HYBRID APPLICATION FOR THE ERECTION OF UP TO 190 RESIDENTIAL DWELLINGS COMPRISING PHASE A - FULL PLANNING APPLICATION FOR THE ERECTION OF 93 DWELLINGS WITH ASSOCIATED WORKS (INCLUDING ACCESS, PUBLIC OPEN SPACE, LANDSCAPING, SUSTAINABLE URBAN DRAINAGE SYSTEMS AND OTHER ASSOCIATED WORKS) AND PHASE B - OUTLINE PLANNING APPLICATION FOR UP TO 97 DWELLINGS (WITH ALL MATTERS RESERVED); HALSNEAD GARDEN VILLAGE, PHASE 3, LAND TO THE SOUTH OF HALSNEAD PARK, AND TO THE NORTH OF THE M6, KNOWSLEY, L35 1QR

PLANNING REFERENCE 26/00166/HYB

In response to the comments received from James Towers of ESS, dated 8th October 2026, in relation to the application above, please find our responses below with any relevant information or updated documents attached.

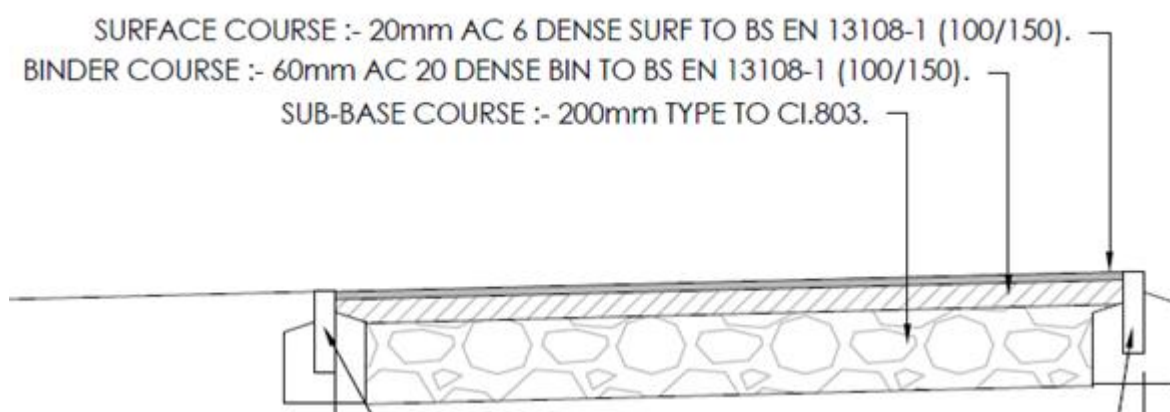
- 11. Shared footway / Active travel** route is to be bitmac surface which is acceptable, can the details of the construction depths be provided to be checked.

This is an extract from our construction details for review:
